DESIGN REVIEW COMMISSION STAFF REPORT

MEETING: July 6, 2016

SUBJECT: **New Hotel at Wood Hollow**
Design Review Workshop #1
File: P2015-091; Design Review
APN 125-202-13 and -14; 7701 Redwood Blvd.

SITE PLAN

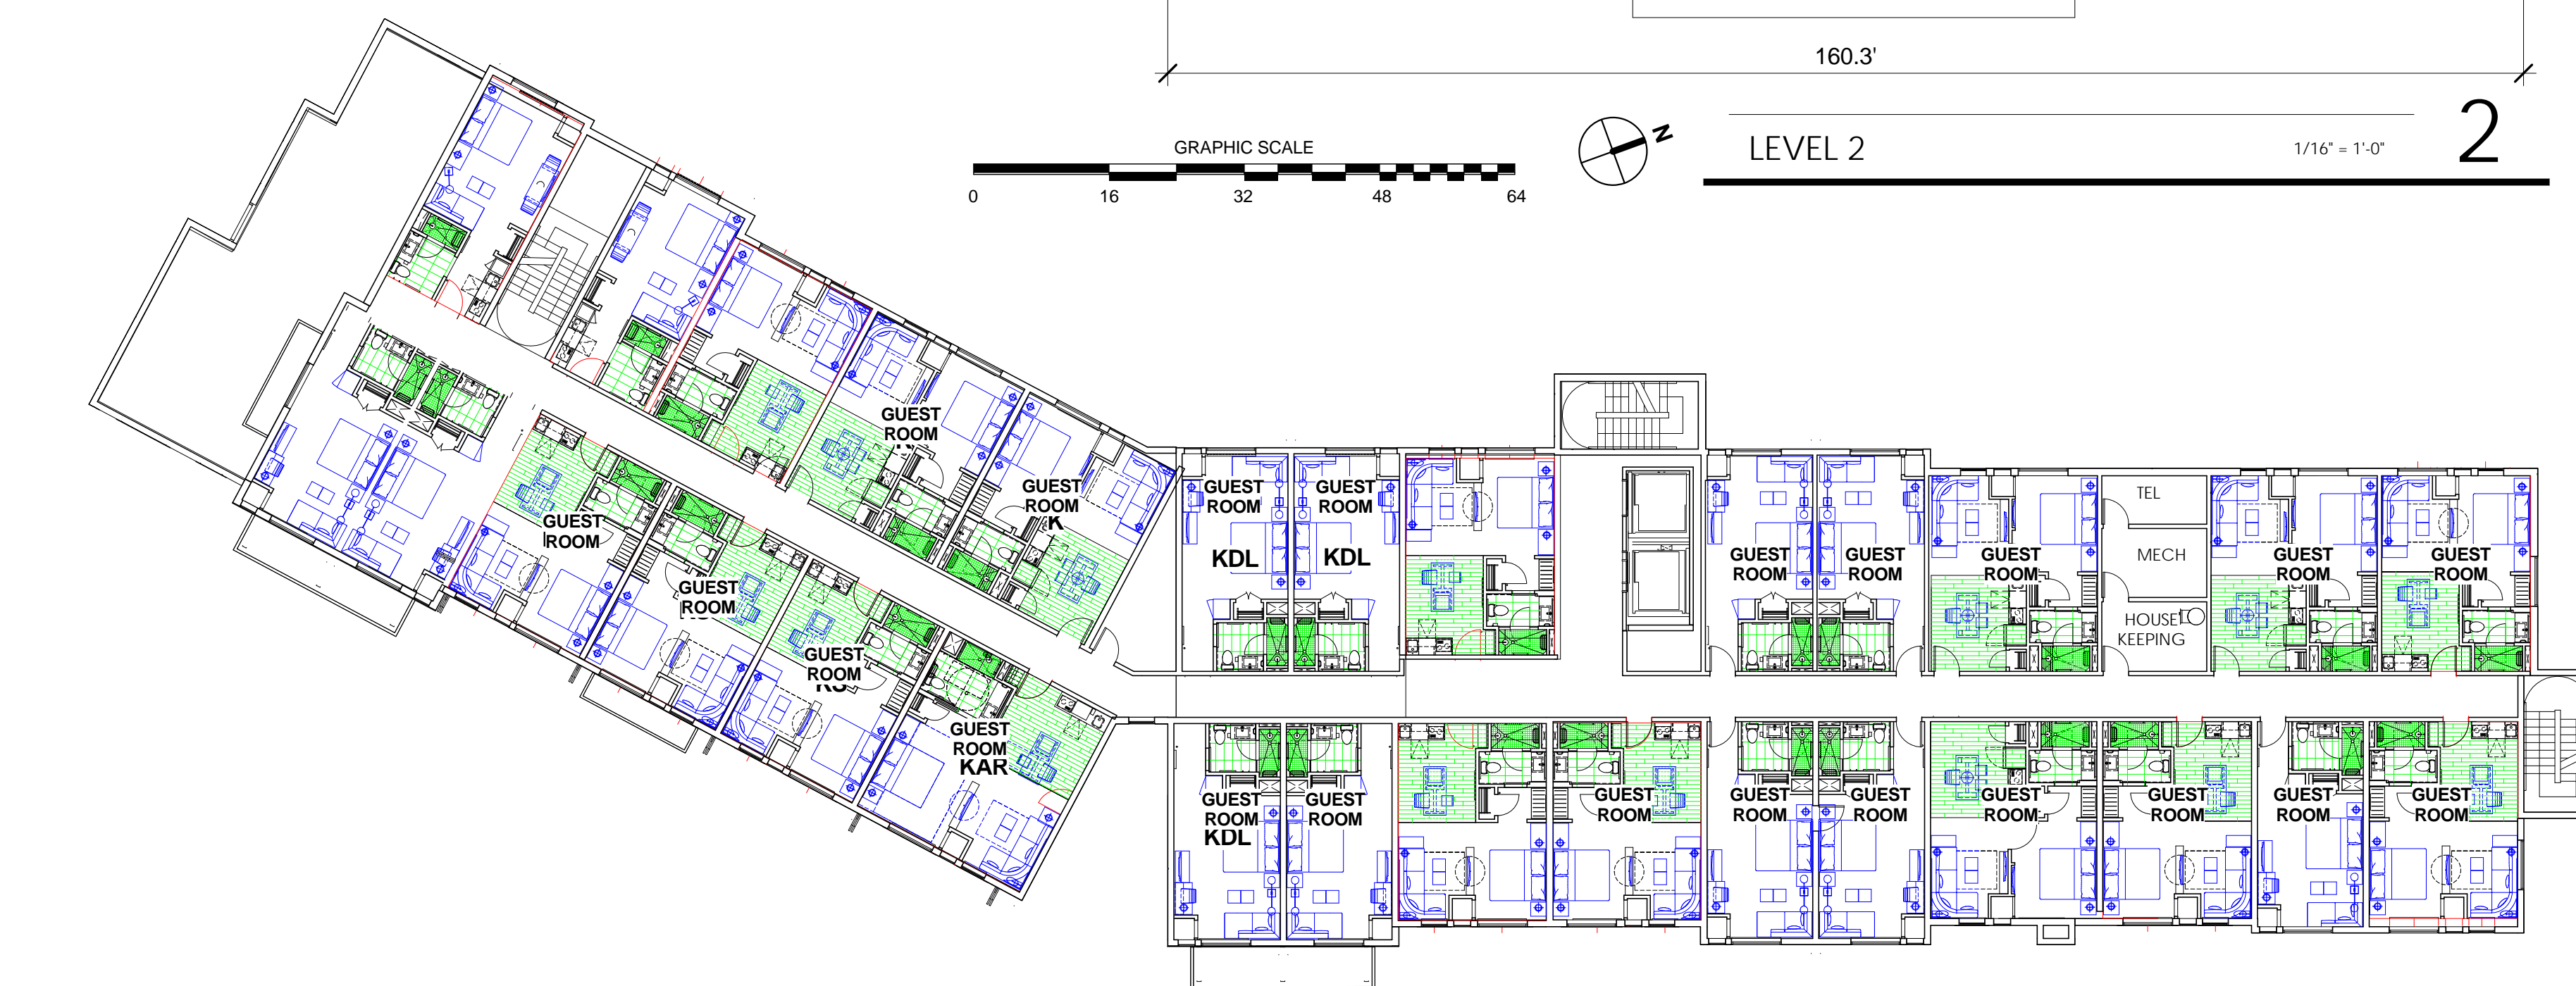
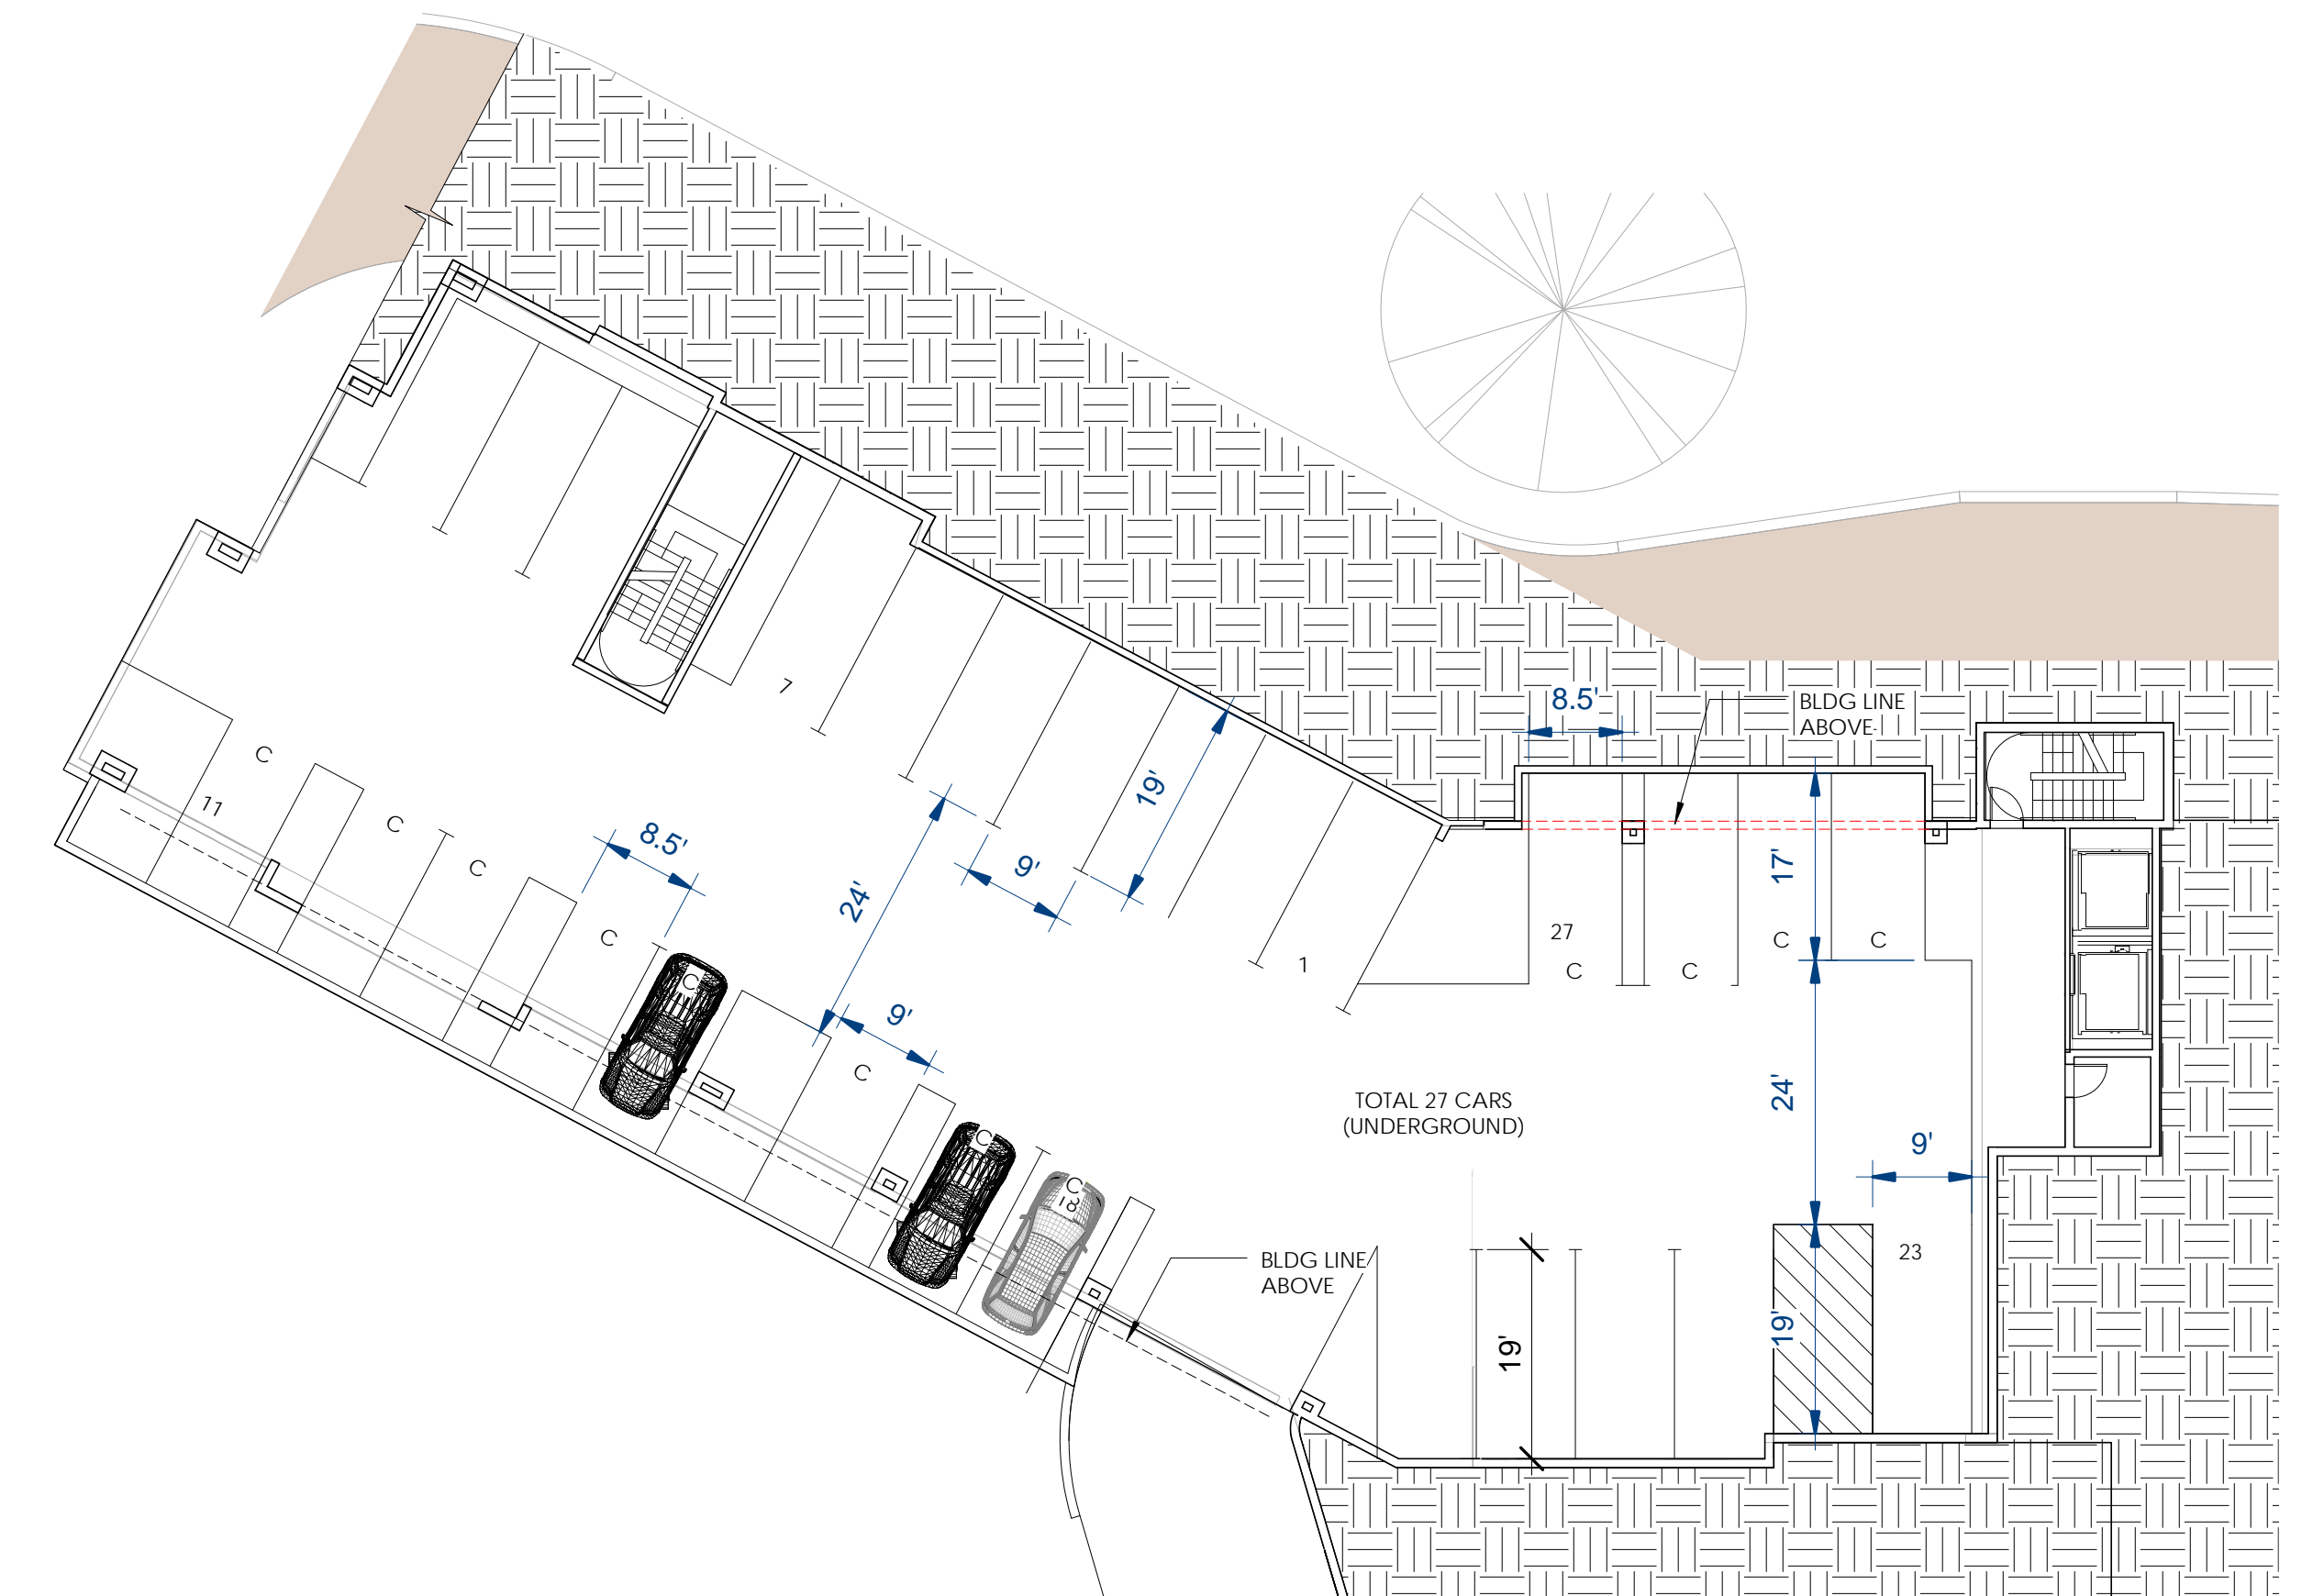
As mentioned in the Project Description, the building has been proposed for the developable portion of the site, bounded on the east by the PG&E Easement, the south by a wetland, and the west and north by slopes with oak trees. The front of the building faces the east, with a parking lot constructed over the PG&E easement and wrapping around the north side of the structure. A retaining wall to the north and west of the building has been proposed to allow the construction of a firetruck access around the west side of the building. The vehicular access/entry to the building is from the Redwood Boulevard frontage, and drops in elevation to the proposed parking lot. A secondary, emergency-only access is shown at the Wood Hollow Drive frontage as required by the Novato Fire Protection District, and will have removable bollards to prevent public access.

The entry on the east side of the building would have a porte cochère, with a plaza and swimming pool to the south. Just south of the plaza would be a ramp from the parking area down to the

parking garage under the building. A retaining wall adjacent to the ramp is proposed to minimize fill within the wetland setback. The retaining wall is not permitted within a 15-foot setback from the PG&E easement, so the applicant is requesting a localized encroachment within the 20-foot wetland setback for a fill slope to accommodate the ramp in this location.

Staff requests that the Commission provide feedback to the applicant regarding the overall approach taken with the site plan, including: context with the surrounding setting, the location/orientation/massing/architecture of the building, on-site circulation, open and basement parking, and ancillary site improvements.
